APPENDIX C

LEEVE WALL STRUCTURAL DESIGN SUMMARY

APPENDIX D
COUNCIL COMMENTS
DATED 21 AUGUST 2024

Re:45-57 Moxon Road, Punchbowl - State Significant Development Application (SSD-71454709) Post-Approval Consultation - Canterbury Bankstown City Council

DRAWING TITLE	SKETCH ONLY - LEVEE WALL SUMMARY
DRAWING No	Co13924.02-SKS-241017-01
ISSUE	0

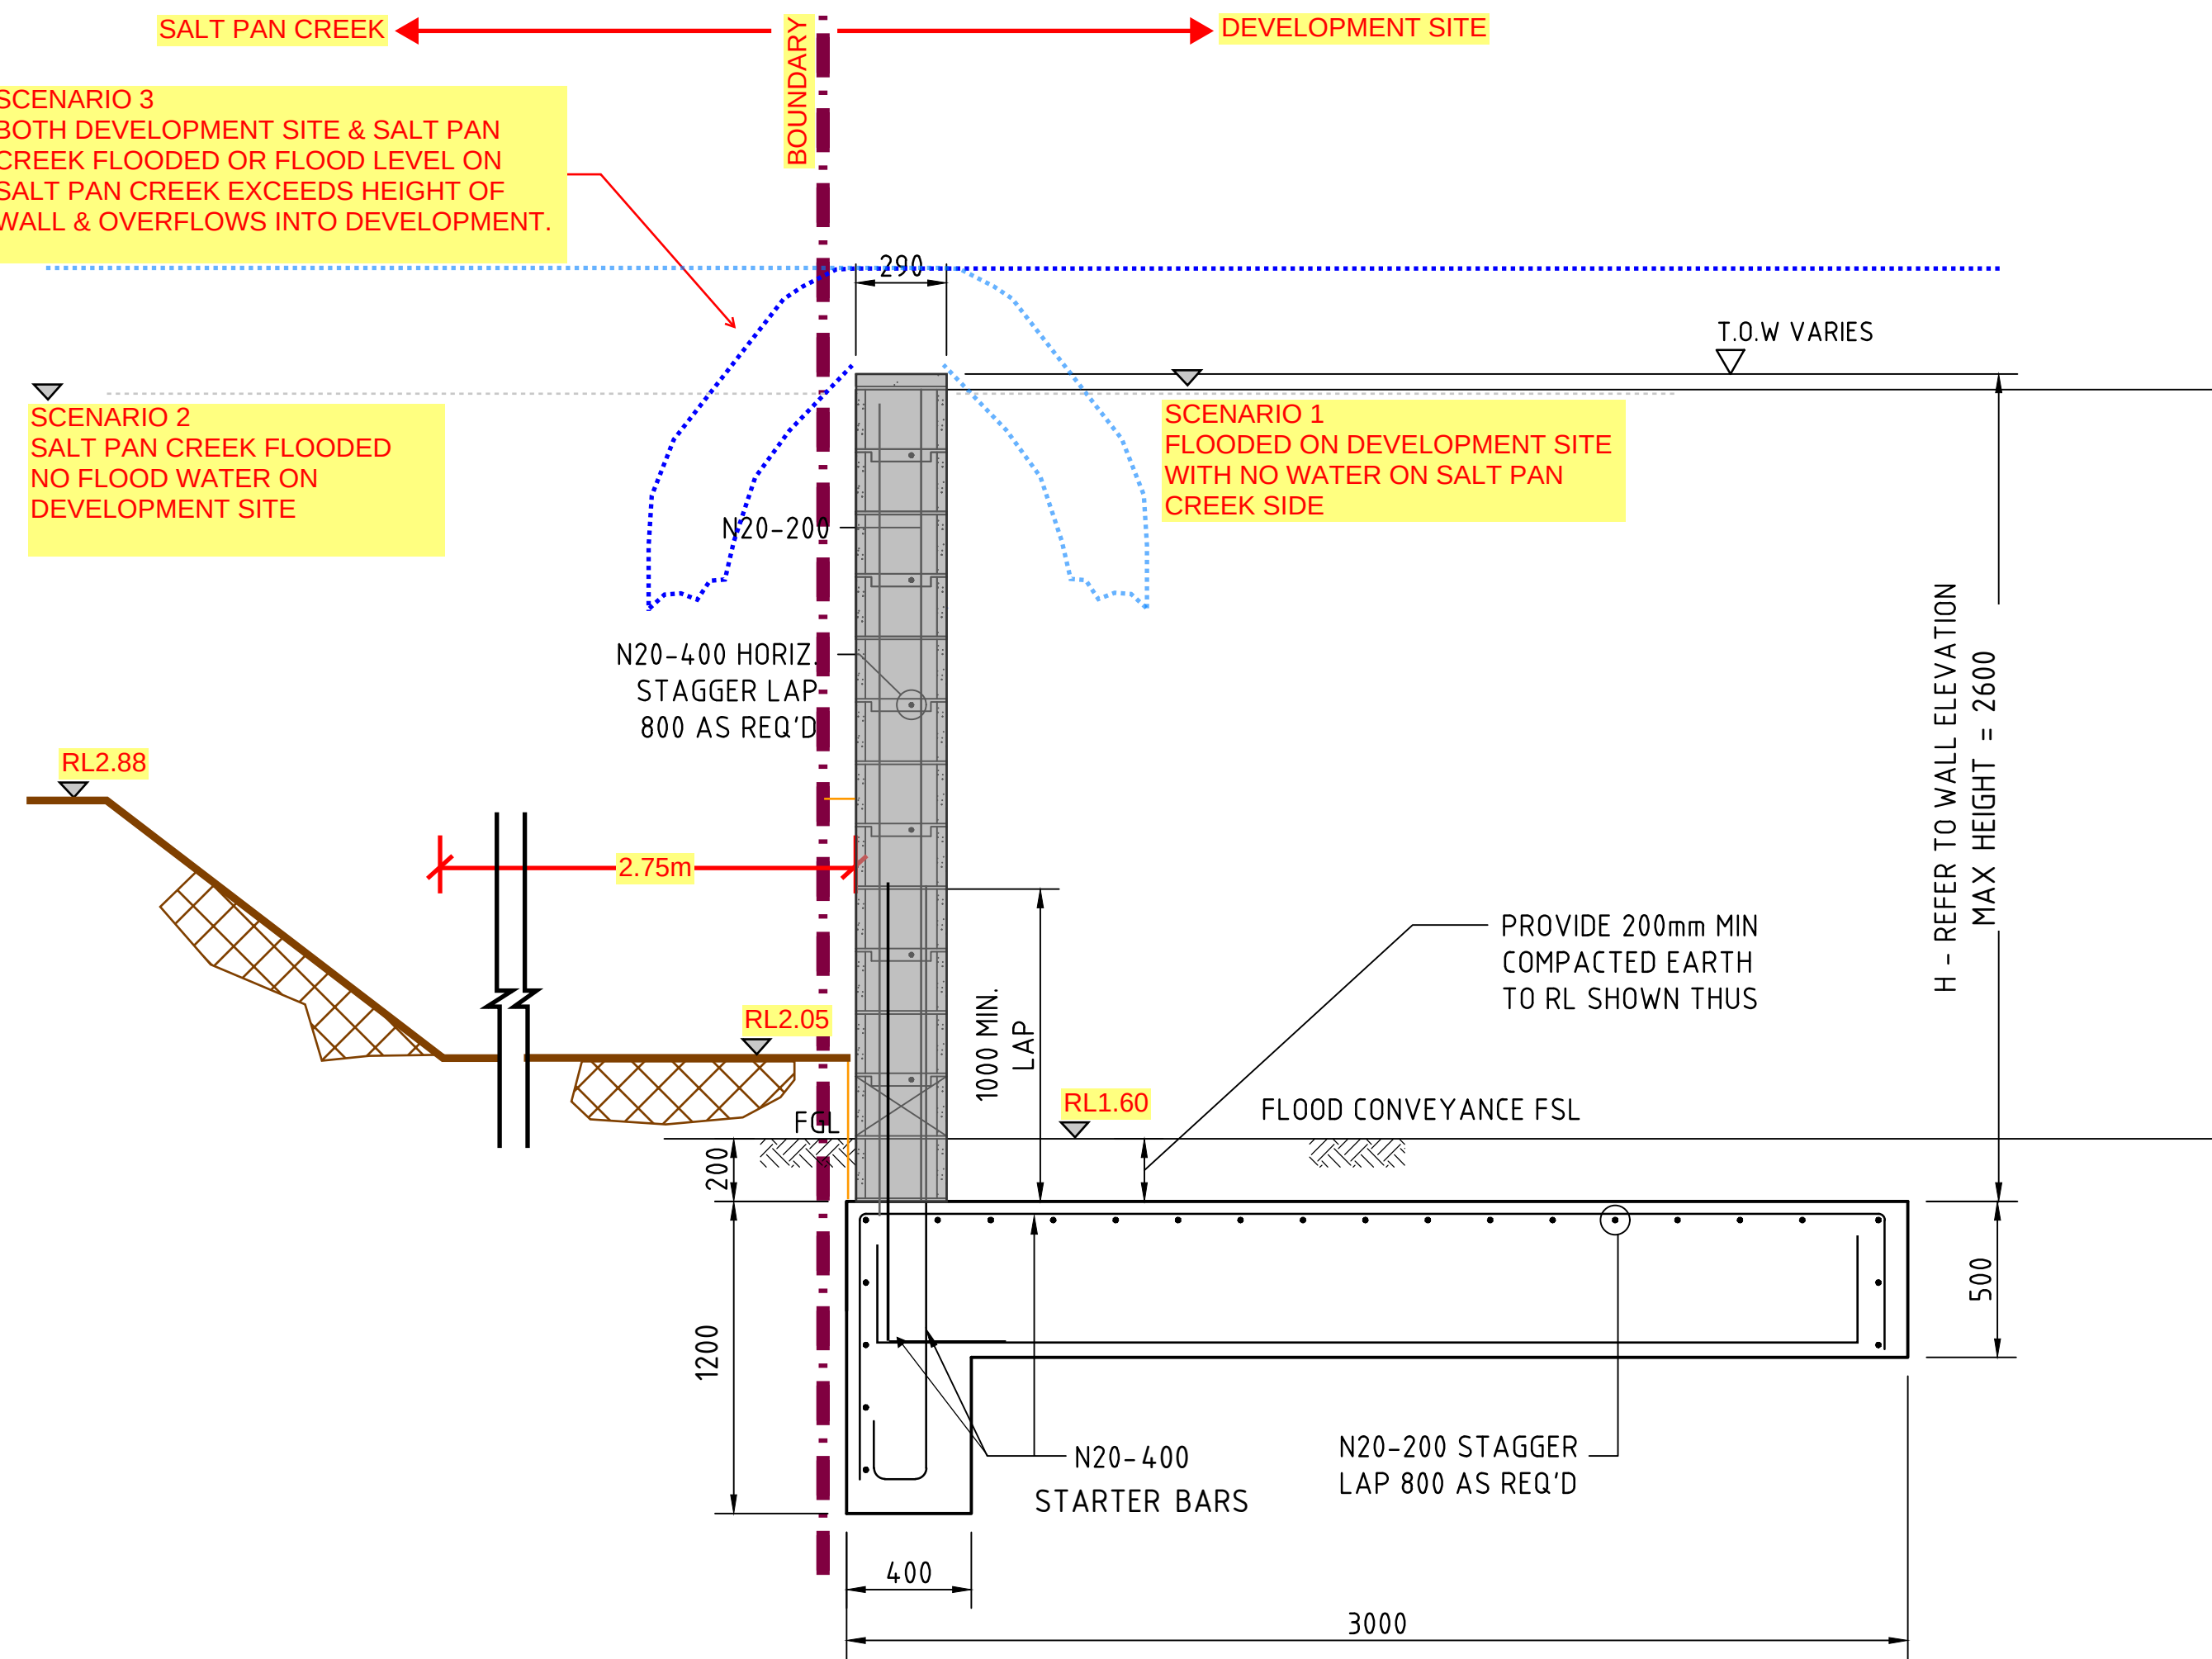
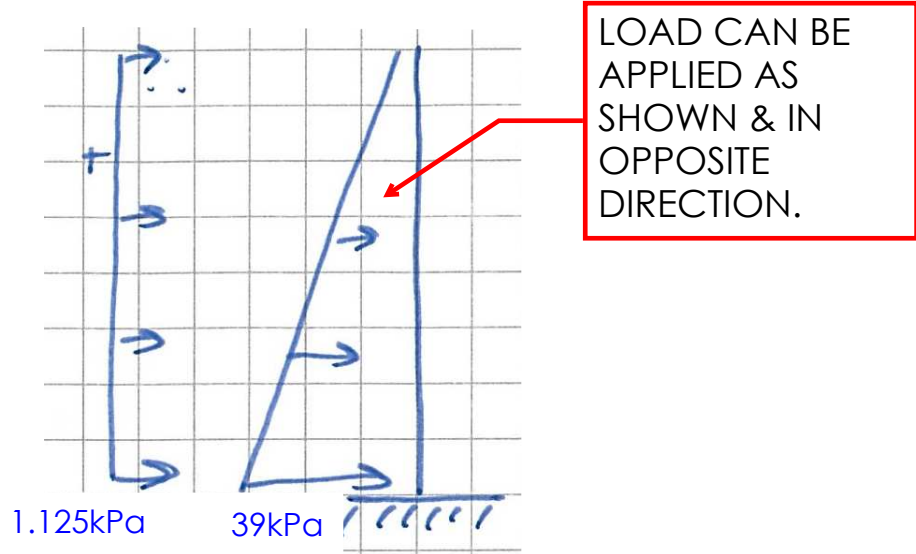
Note that there are different maximum loading scenarios to consider

Scenario 1: The development site is flooded and the Salt Pan Creek side is dry.
Scenario 2: The development site is dry and the Salt Pan Creek side is flooded.
Scenario 3: Both the development site and Salt Pan Creek are flooded (Probable Maximum Flood), OR flood level on salt pan creek exceeds height of wall and overflows into development.

Governing design scenario for strength is scenario 1 and 2 (bending alternate directions)
Governing design scenario for stability is scenario 2 -> no restoring moment from the water assist in overturning.
